MACK TRUCKS, INC.
2100 MACK BOULEVARD
P.O. BOX M
ALLENTOWN, PA 18105-5000

SUBJECT: Vehicle Safety Recall - SC0330
DRL Module

SC330

Subject: Daytime Running Light (DRL) Module Replacement — CXU, CHU, GU, MRU and LEU Models

Figure 1 — Daytime Running Light Module (Part No. 116MO39A)

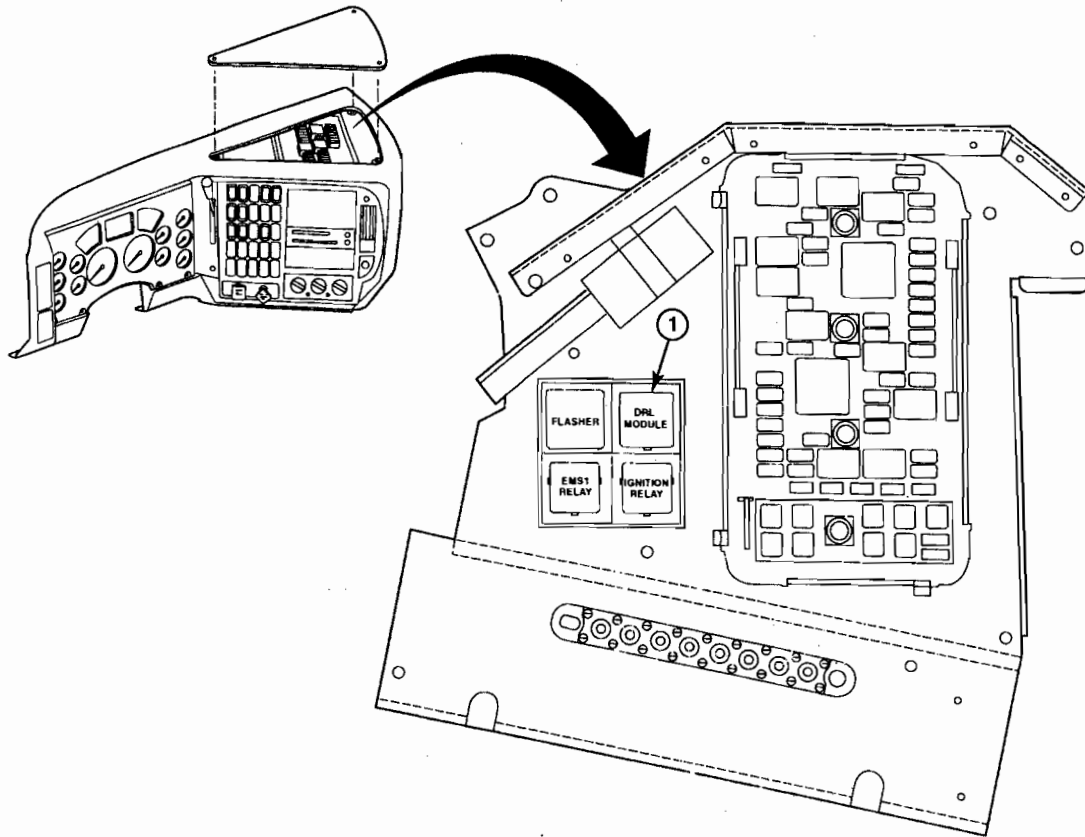
Replace the existing DRL module with a new module (part No. 116MO39A).
